Ms J Callaghan

GCS Water & Environmental Consultants (Pty) Ltd

17 June 2022

RE: IMVUKUZANE RESOURCES (PTY) LTD - APPLICATION FOR ENVIRONMENTAL AUTHORISATION - PROSPECTING RIGHT AND RELATED INFRASTRUCTURAL ACTIVITIES – FULENI RESERVE 14375 GU, PORTION, ULUNDI LOCAL MUNICIPALITY, KWAZULU-NATAL: KZN30/5/1/1/2/10747 PR – COMMENTS ON DRAFT BASIC ASSESSMENT REPORT

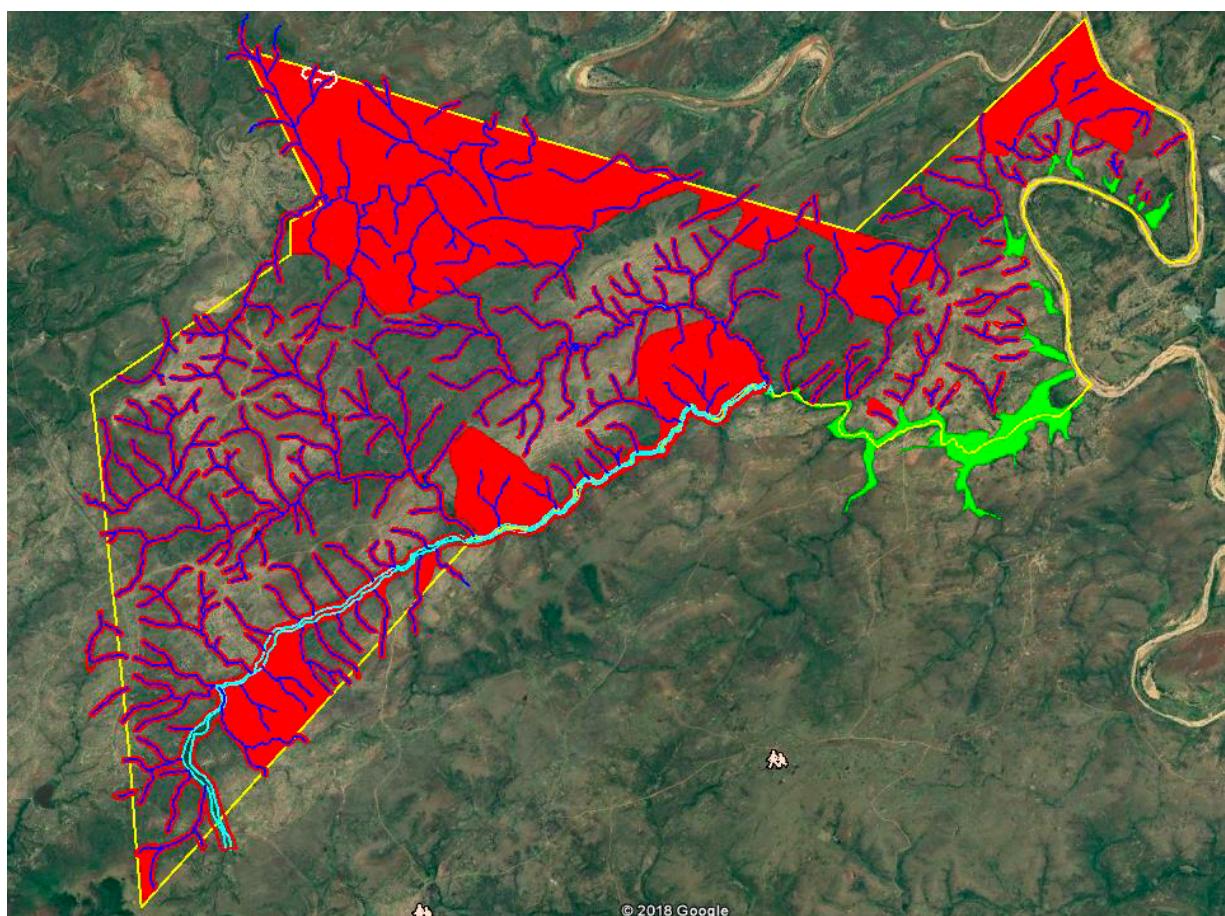
60. Figure 4.9 of the Ecological Impact Assessment and Wetland Report⁹ presents the red areas as no-go areas.

61. Although the EAP and the specialist did not plot the 55 boreholes in relation to these no-go areas, it is evident that a number of boreholes fall within these areas, including points 4, 7, 42, 35 – 38. Thus, almost 20% (10 of the 55) boreholes should not be approved as they fall within these no-go areas.
